OFFICIAL TRANSCRIPT OF PROCEEDINGS

Agency: Nuclear Regulatory Commission

Title: IIT Interview of Faust Rosa

## DESIGN CHANGE REQUEST

APPLICABLE PAGE/SKETCH (DRAWING NO.) 51-C-VIN0130-100 REV. A  
(CIRCLE ONE) Sheet 9

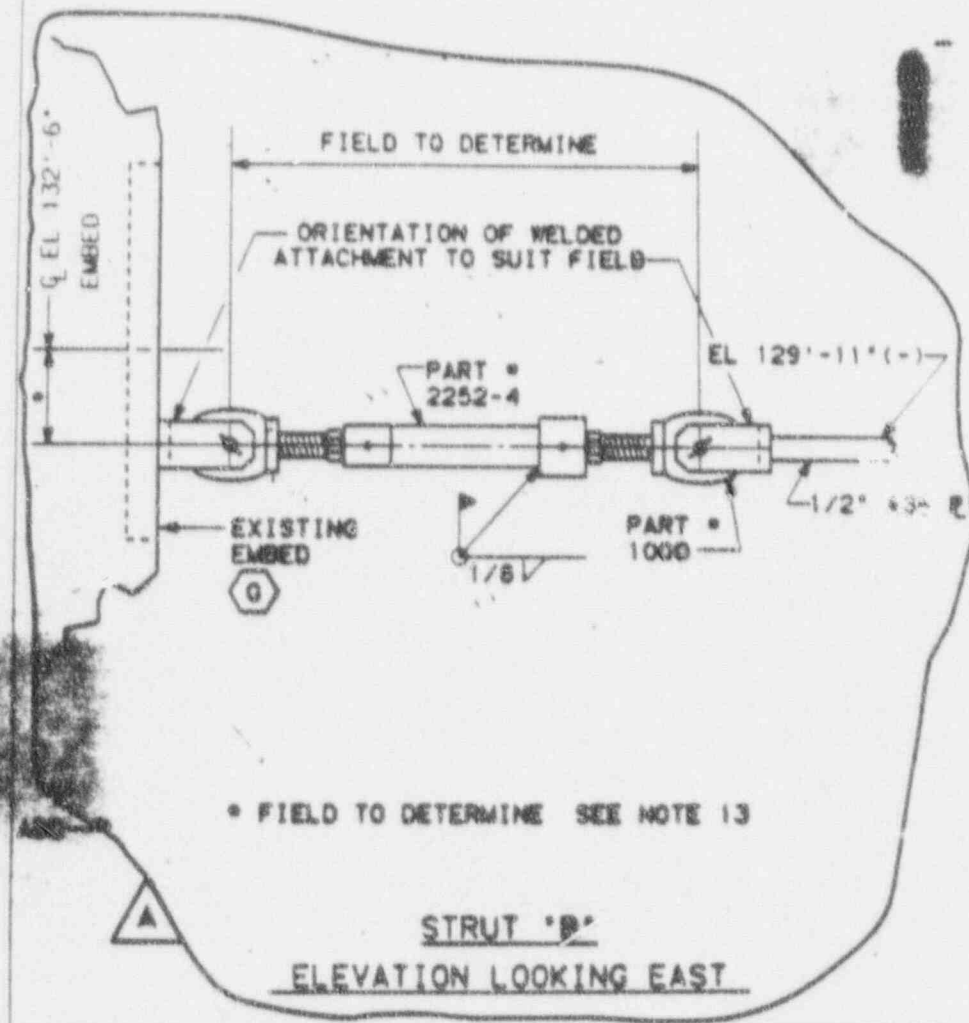
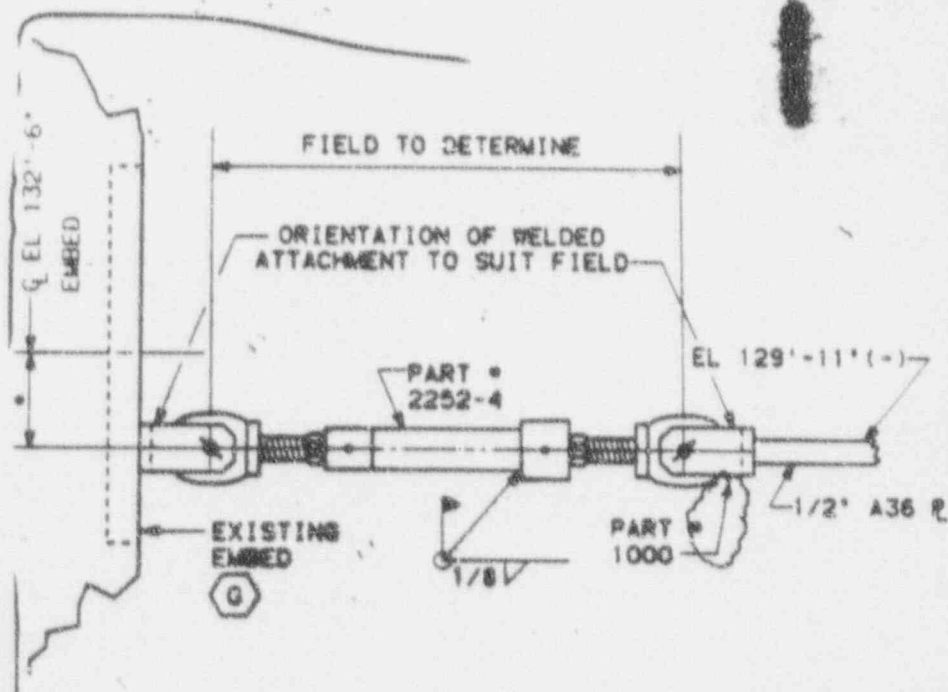
FCR NO. 90-VINO130-FOO/DCP SDCP or MDD NO. 90 VINO130SAFETY RELATED? YES ☒ NO ☐ EXTENSIVE? YES ☐ NO ☒APPLICABLE PAGE/SKETCH/DRAWING NO. 51-C-90VINO130-FOO/REV. A  
(CIRCLE ONE) SHEET 4, 6, 7, 13, 14REASON FOR CHANGE: Change Weld size to match thickness  
of member. Identify part number correctly. Change  
installation notes.DESCRIPTION OF CHANGE: See sheets 3, 5, 7, 9, 11, 13, 15, 17,  
19 & 21 for changesFCR ORIGINATOR: AK1Jha

APPLICABLE PAGE/SKETCH/DRAWING NO. 51-C-90-VINC130-100 REV. A  
(CIRCLE ONE) SHT. 5 OF 9

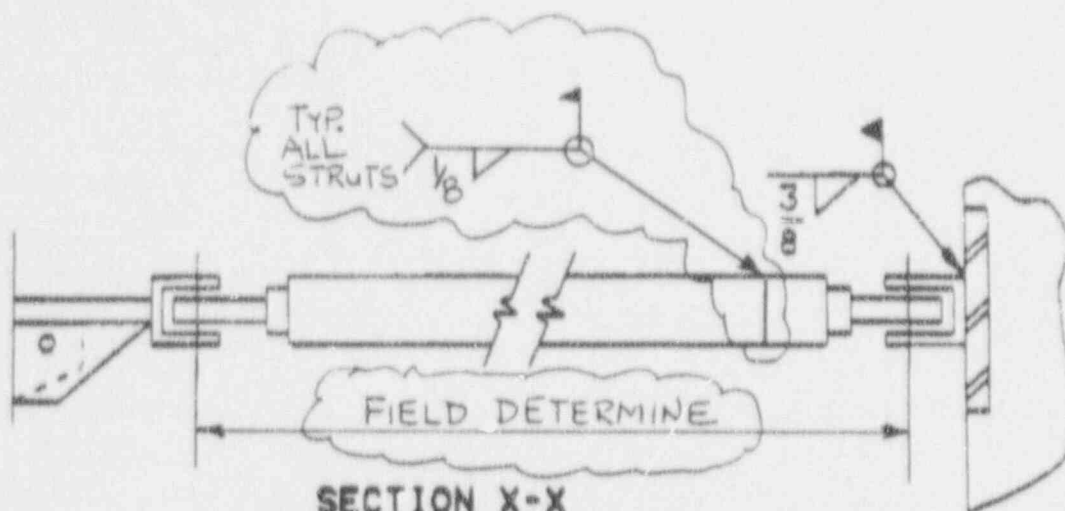
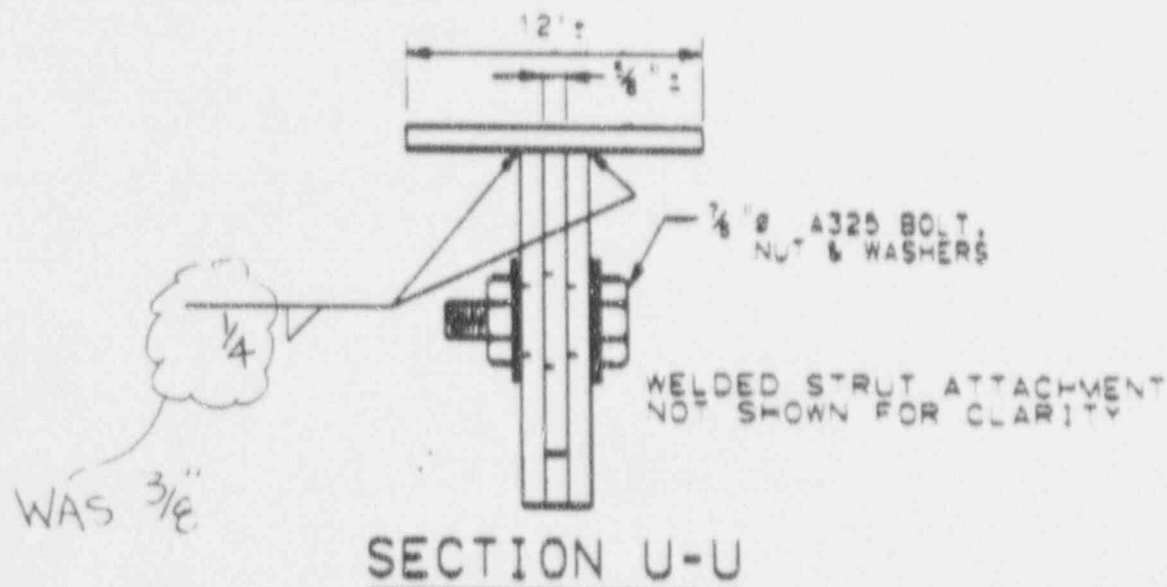
FCR NO. 90-VIN0130-F003 (DCP) SDCP or MDD NO. 90-VIN0130-C-1SAFETY RELATED? YES X NO   : EXTENSIVE? YES    NO XAPPLICABLE PAGE/SKETCH (DRAWING NO.) SI-C-90-VIN0130-100 REV. A  
(CIRCLE ONE) SHT 5 & 7 OF 9 (REF FCR-F002)REASON FOR CHANGE: CONFLICTING WELD SIZE SHOWN ON  
SHEET 5 AND WELD FOR STRUT NOT SHOWN ON  
SHEET 7.DESCRIPTION OF CHANGE: WELD SIZE SHOWN CORRECTLY FOR  
SHEET 5 AND STRUT WELD SHOWN FOR SHEET 7.  
SEE ATTACHED SHT. 2 AND 3 OF 3 FOR CHANGES.FCR ORIGINATOR: [Signature] 13-28-90  
DATEAPPROVED: [Signature] 13/28/90  
RESPONSIBLE ENGINEER/ENGINEERING SUPERVISOR DATE

APPLICABLE PAGE/SKETCH/DRAWING NO. SI-C-90-VINO130-100 REV. A  
(CIRCLE ONE) (SHT. 6 OF 9)

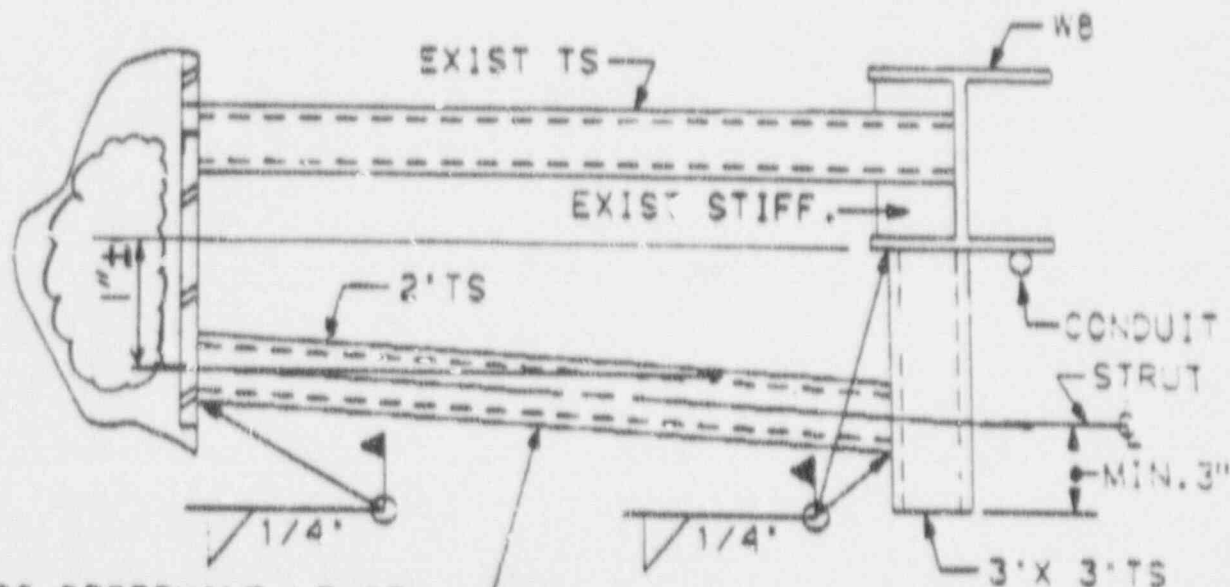
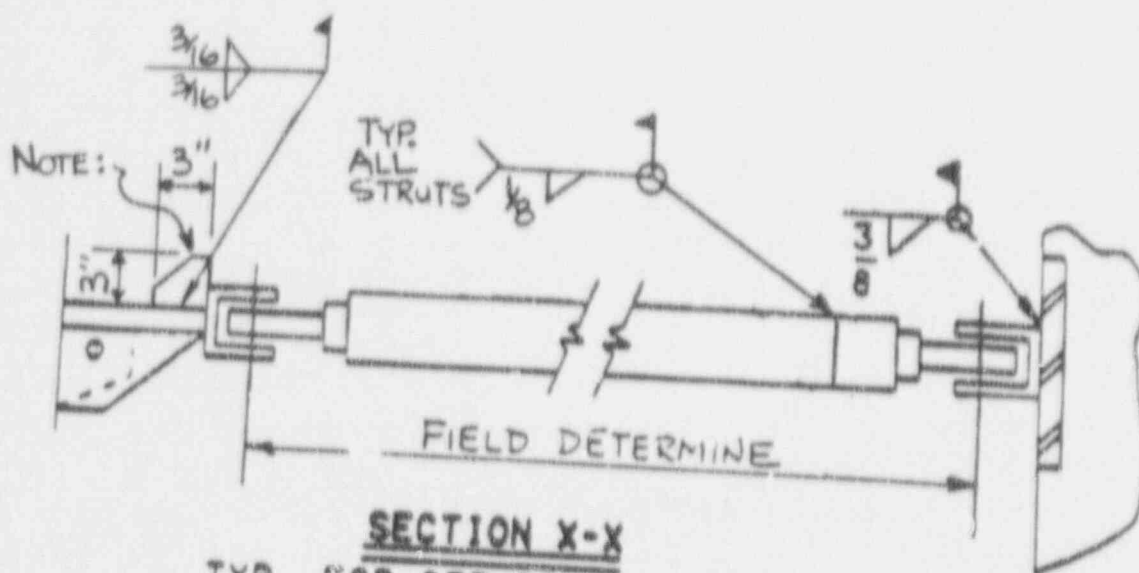
FIELD TO DETERMINE LENGTH  
AFTER 3' X 3' TS IS WELDED TO WF.
